Your Ref
FP/171/18/PL
Our Ref
PLAN-024069
Date
30/08/2018

Proposal: Erection of 18 No. dwellings, creation of new access, landscaping & associated works.

Site: Land at Stanhorn Grove, Felpham PO22 8FP.
FP/171/18/PL

Southern Water MapGuide Browser

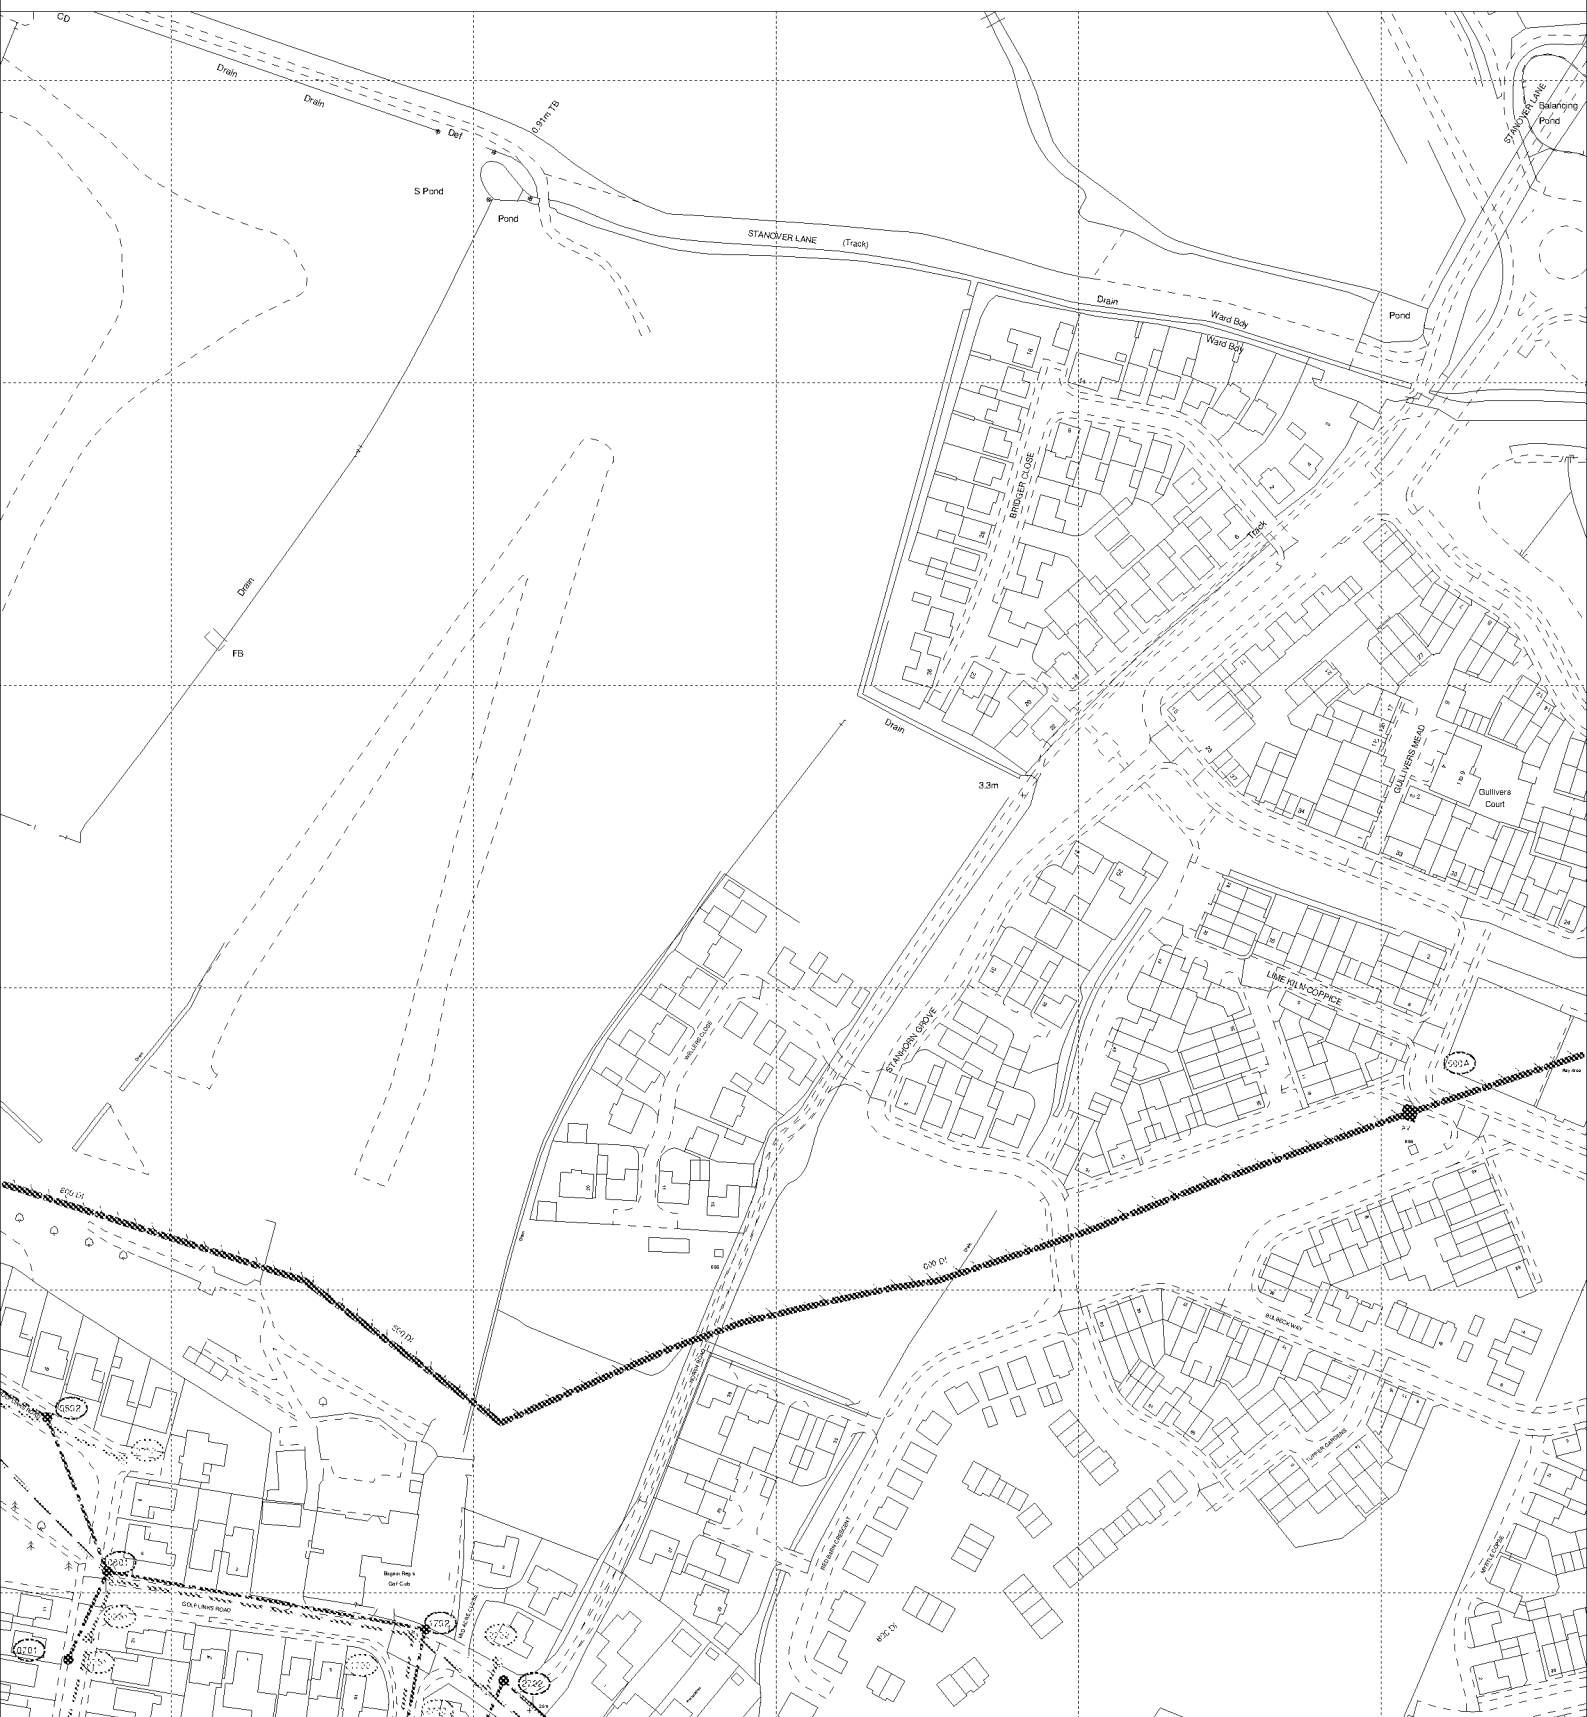
Due to changes in legislation that came in to force on 1st October 2011 regarding the future ownership of sewers it is possible that a sewer now deemed to be public could be crossing the above property. Therefore, should any sewer be found during construction works, an investigation of the sewer will be required to ascertain its condition, the number of properties served, and potential means of access before any further works commence on site.

The positions of pipes shown on this plan are believed to be correct, but Southern Water Services Ltd accept no responsibility in the event of inaccuracy. The actual positions should be determined on site.

The applicant is advised to discuss the matter further with Southern Water, Sparrowgrove House, Sparrowgrove, Otterbourne, Hampshire SO21 2SW [REDACTED]
[REDACTED] www.southernwater.co.uk".
